MAP OF SURVEY

125 NE 17th Street, Delray Beach, FL 33444

## Board of Adjustment

Meeting: November 7, 2019 | File No.: 2019-292-VAR-BOA | Application Name: 125 NE 17<sup>th</sup> Street – Variance

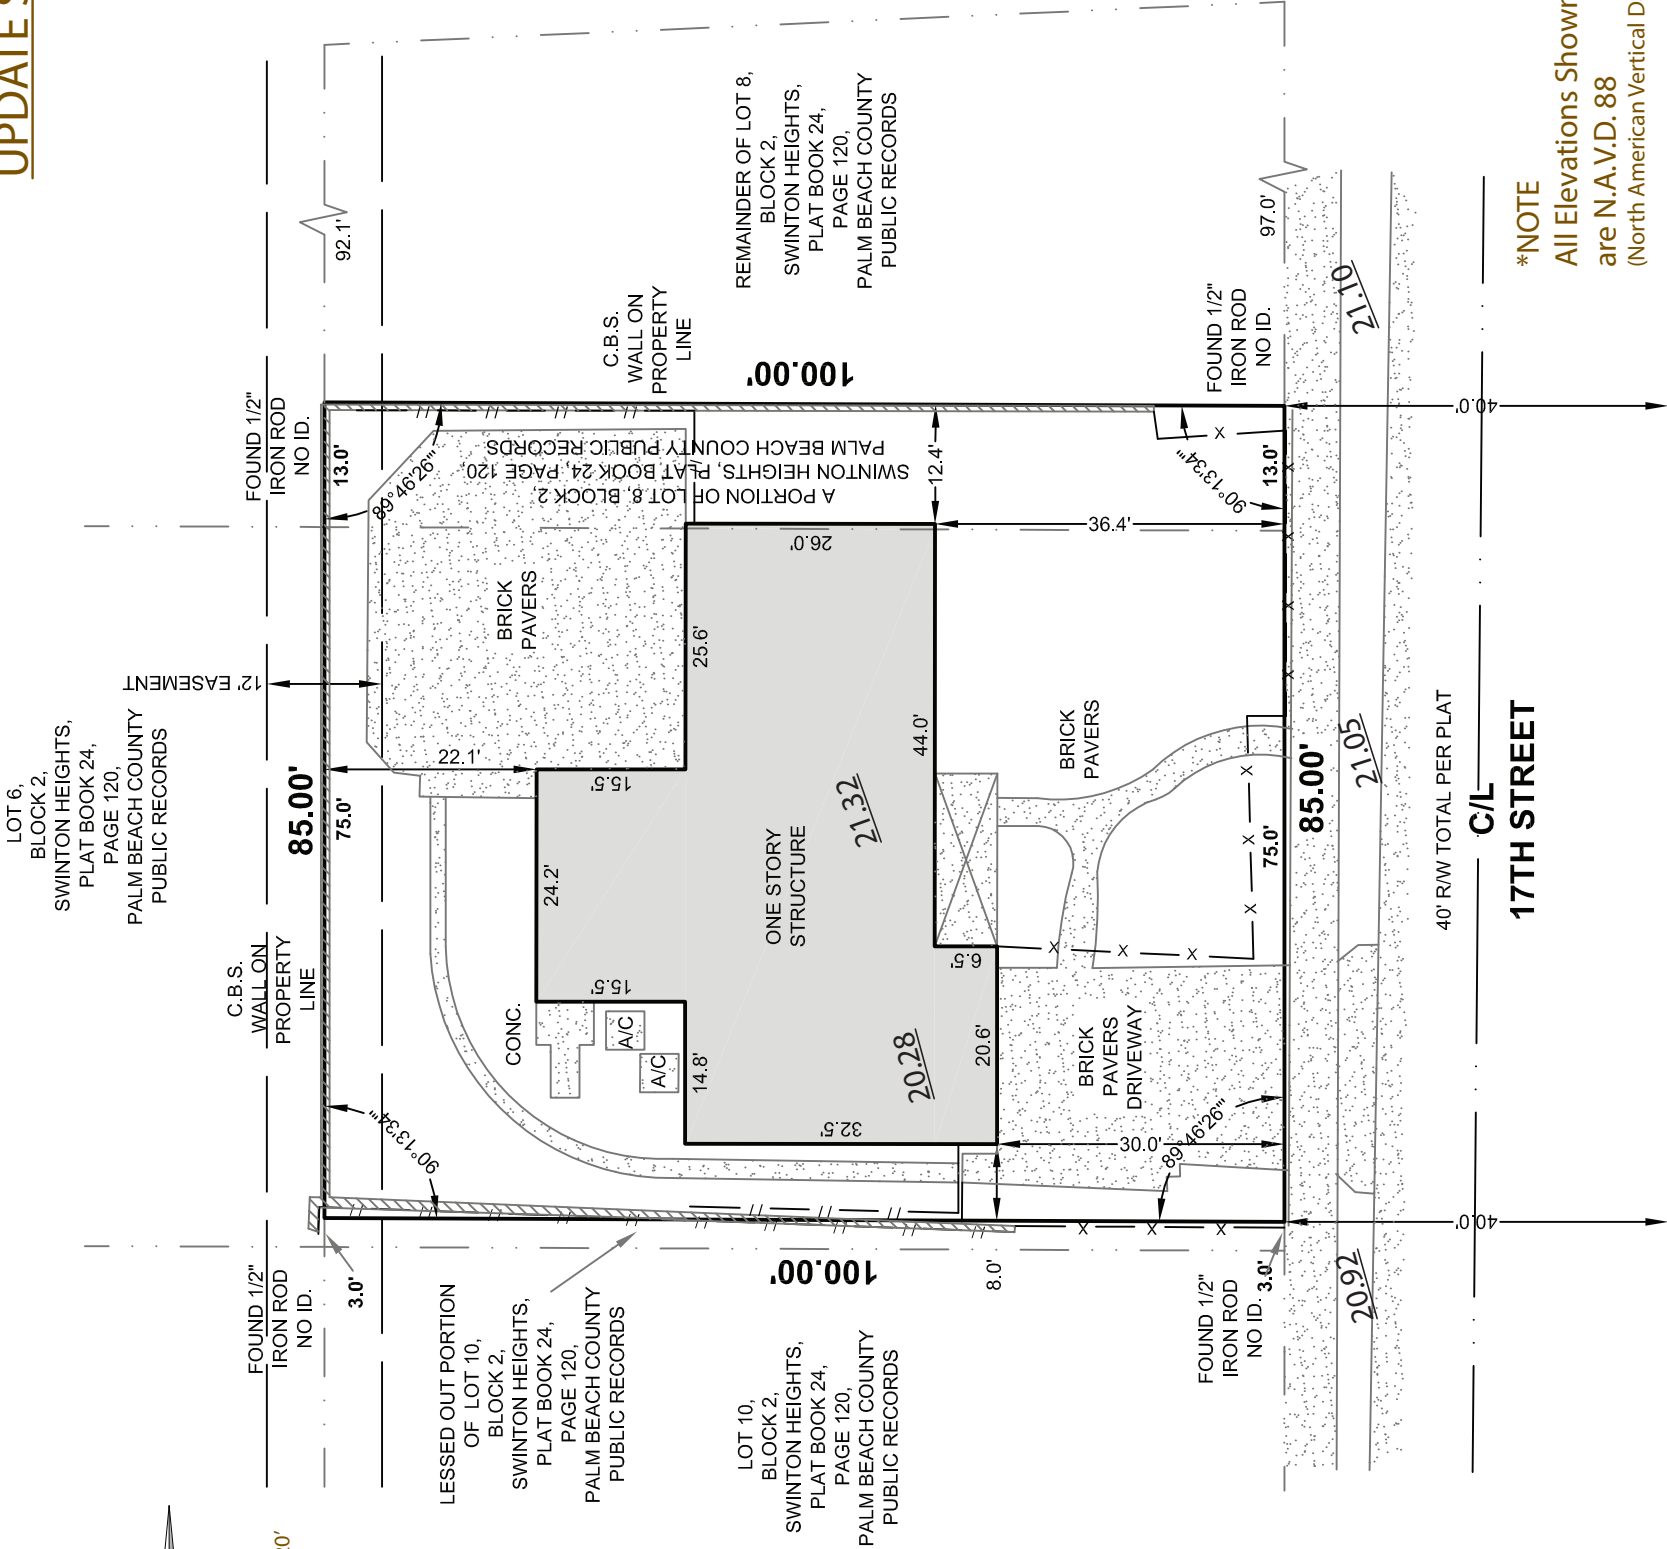
**Staff Analysis:** The following chart compares the Lot configuration provided in the survey with the minimum requirements for the R-1-AA zoning district set forth in LDR Section 4.3.4 (K) Development Standards Matrix:

When the existing conditions of the subject site are compared to the R-1-AA zoning regulations in the LDR, the information reveals that (1) the existing property area is less than the minimum required, and (2) the side interior setback on the west is less than the minimum required. First, the existing property area is 8,500 sf, which is 1,000 sf less than the minimum required 9,500 sf, thus the site is a Nonconforming Lot of Record. Second, the existing side interior setback on the west side of the property is 8', which is 2' less than the minimum required 10' side setback, thus the house is a Nonconforming structure. It is important to note that pursuant to LDR Section 1.3.5 (B)(1), "enlargement or alteration of a Nonconforming structure in a way that complies with applicable dimensional standards and does not create any new nonconformity, or alteration of the structure in a way that decreases the degree of nonconformity is permitted."
